UNITED STATES
NUCLEAR REGULATORY COMMISSION
WASHINGTON, D. C. 20555

SUBJECT: MINUTES OF THE EIGHTH RESEARCH REVIEW GROUP (RRG)
MEETING FOR THE FUEL CYCLE FACILITY SAFETY RESEARCH
PROGRAM (FCFSRP)

FUEL CYCLE FACILITY SAFETY RESEARCH PROGRAM
RESEARCH REVIEW GROUP (RRG) MEETING #8

FIGURE 4-8. NBS QUASI-STEADY MODEL CONTROL VOLUMES AND ROOM GEOMETRY

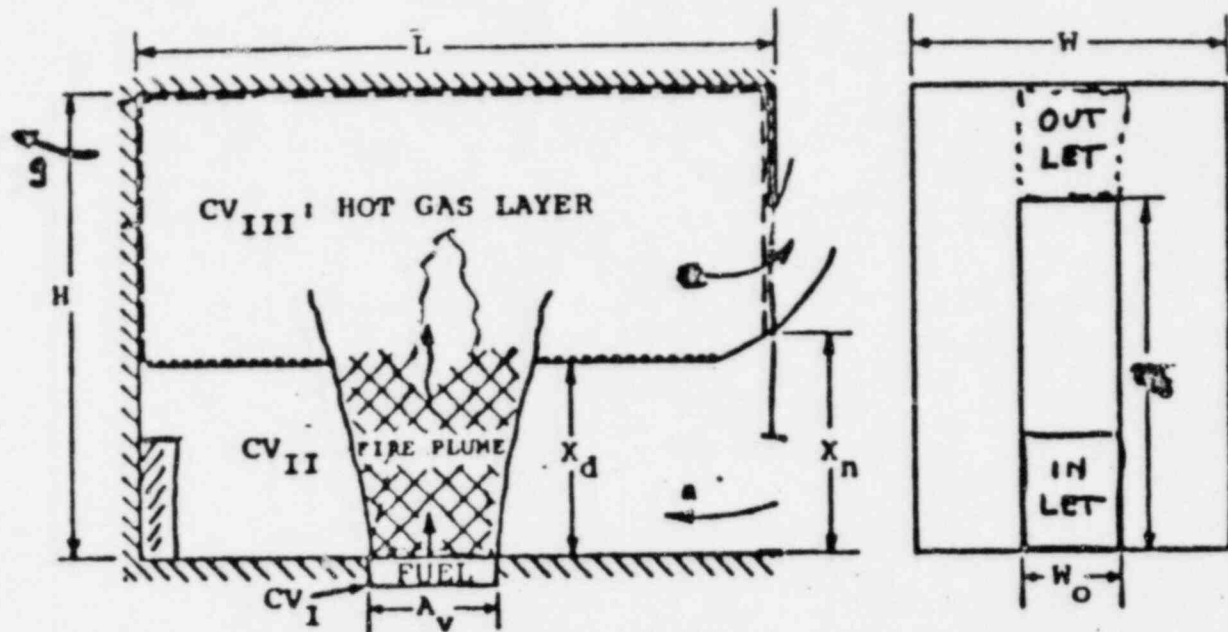
the same diagram modified to show how the geometry changes for the fuel cycle facility problem. Here the doorway is replaced by an inlet and outlet to the ventilation system and there is forced, rather than free, ventilation.

- x_d - Height of thermal discontinuity
- x_n - Height of neutral plane
- H - Height of compartment
- L - Length of compartment
- W - Width of compartment
- ~~h_o - Height of doorway INLET & OUTLET GEOM.~~
- ~~w_o - Width of doorway & M(0) outlet~~

TOTAL UO2 RELEASE RATE . VS. TIME

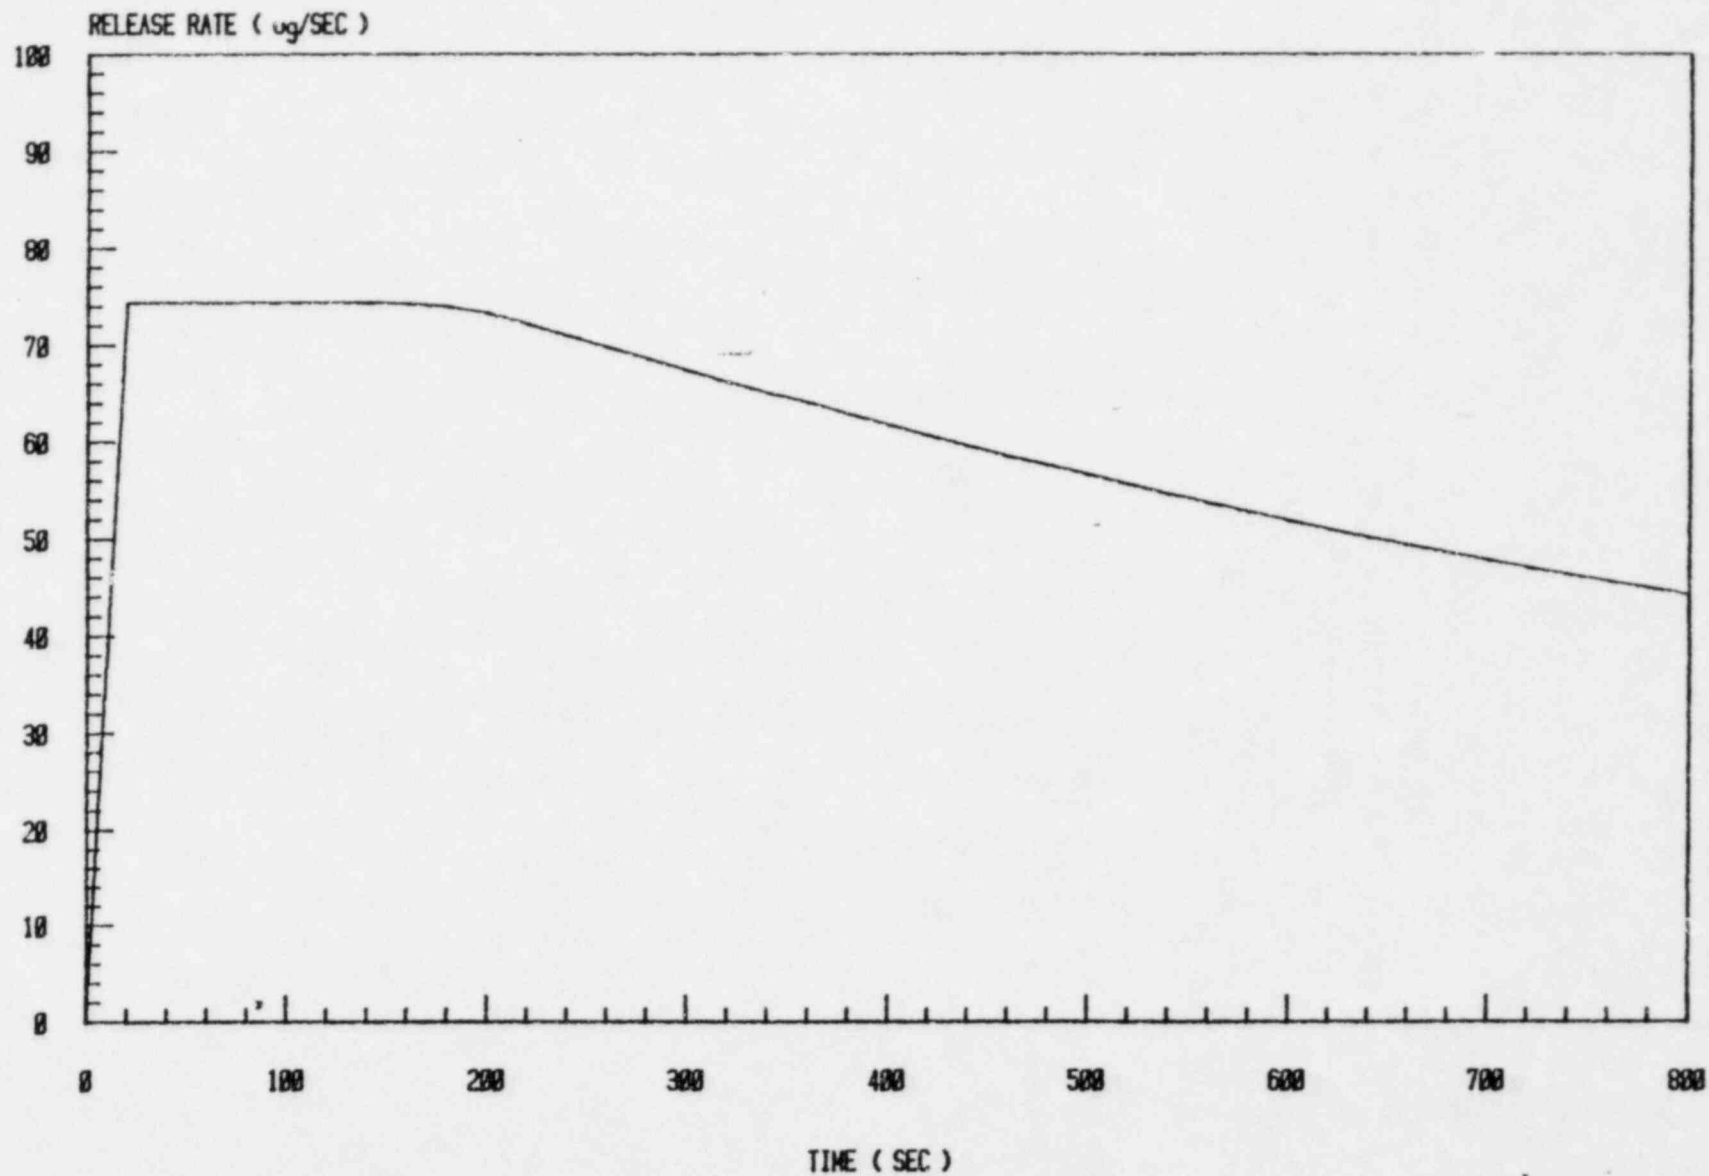
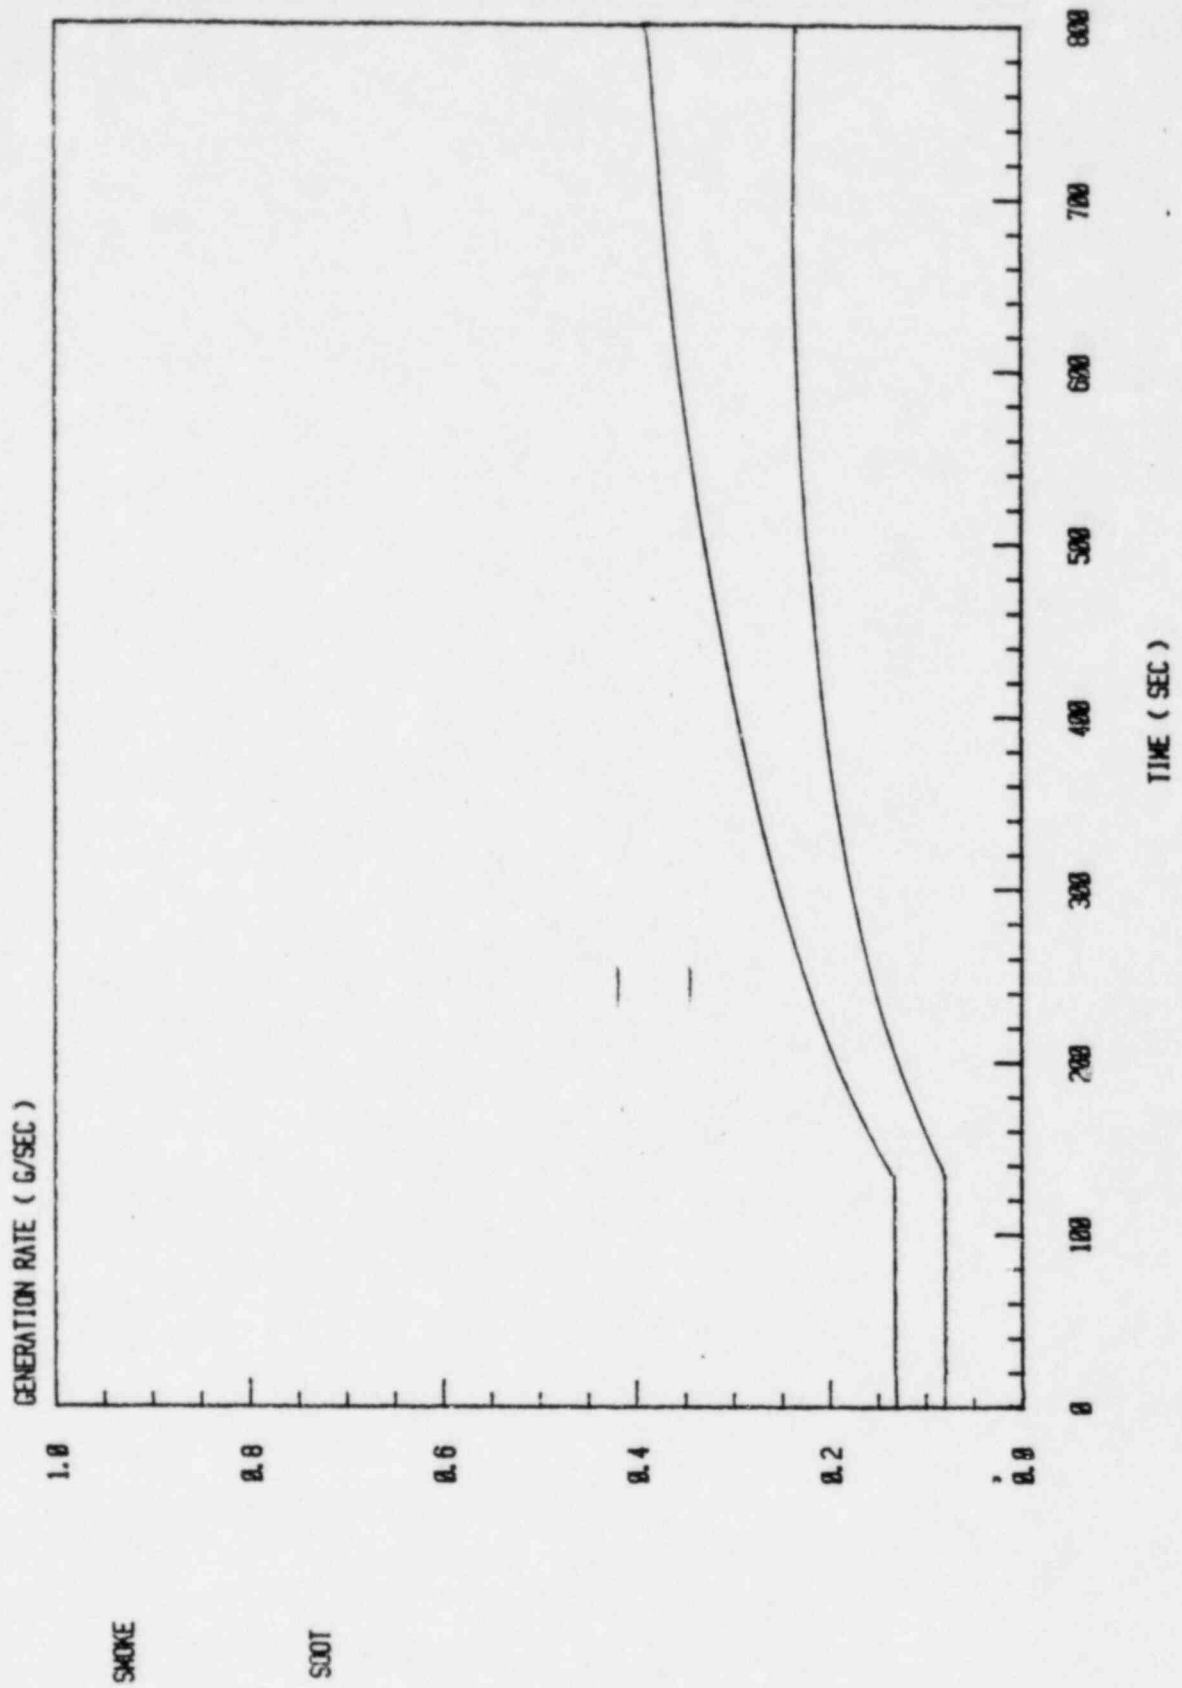
The question arose on why the release rate for the uranium dioxide, shown on page F-39, does not reflect the smoke and soot generation rates shown on page F-37. The two rates should have a similar shape since the radioactive material is made airborne as contaminated smoke. The explanation is that the release rate for the uranium dioxide has the same shape as the mass loss rate, since the model used in FIRIN1 relates the radioactive source term to the mass burning rate. The model was developed in this way because the bulk of the experimental data were taken as release fractions of the total mass of contamination involved in the fire.

B+W FIRE
TEMP. VS. TIME

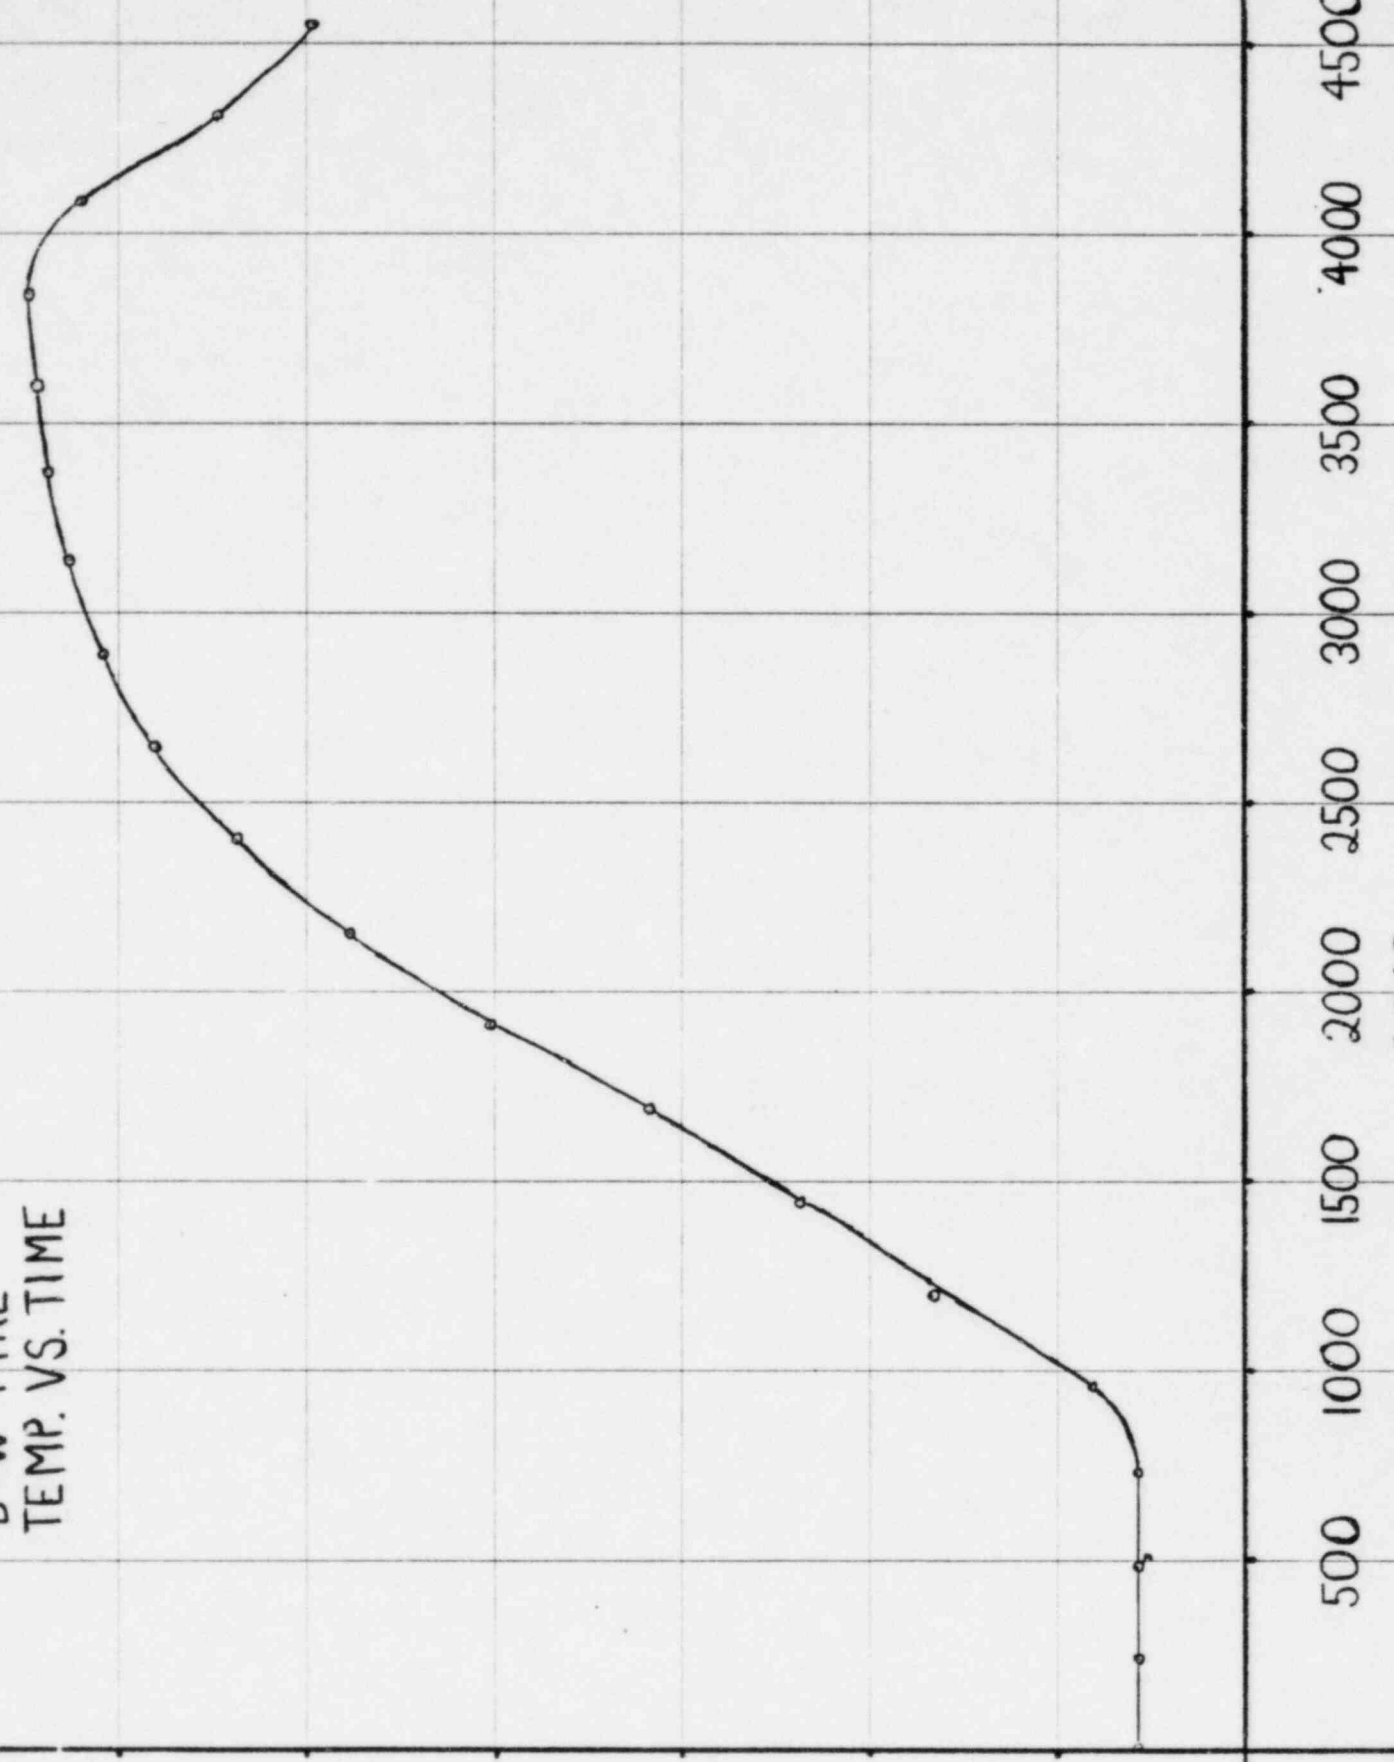
The time history of the temperature in the burn room as determined by FIRAC is shown on page I-6. As can be seen by examining the graph, the temperatures predicted by FIRAC are far in excess of what can be considered reasonable. These excessive temperatures may have been produced by using unrealistic energy source terms in the problem. To explore this question, some additional FIRAC runs were made as shown on page I-7. In these additional runs the total energy input to the burn room was held constant while the burn time and energy input rate were varied. The energy input rates were held at or below 200 KW to ensure realistic energy input rates. The results are shown in the table on page I-7. When particulates were present the system did not achieve a steady state even after several hours. The temperature in the burn room appears to be unrealistically high and still increasing at the end of the run. Further examination revealed that the particulates plugged the HEPA filters causing the gas flow rate to drop to essentially zero. Since the only way for heat to be removed from the burn room is by being carried out in the gas flow, the high temperatures were produced by the continuous addition of heat. To verify this idea some runs were made without particulates. As shown in the table, steady state was achieved in these runs with reasonable final temperatures.

Los Alamos had examined the problem of the excessive temperatures in the typical licensing problem. They indicated that this problem was caused by an unrealistic source term. With the heat input given in the source term the gases in the burn room will be continuously drawn out to the point where there is no gases left. The given source term does not take into account the fact that the fire will adjust itself to the changing flow rates. Los Alamos has correctly analyzed the problem and showed that the temperature in the burn room reaches a maximum of about 600°F. Since the NRC used the source term guidelines contained in the FIRAC user manual in analyzing the problem, it was agreed that these guidelines need to be revised to clarify the procedures for developing a realistic source term description. Los Alamos will make the necessary revision in the next few weeks.
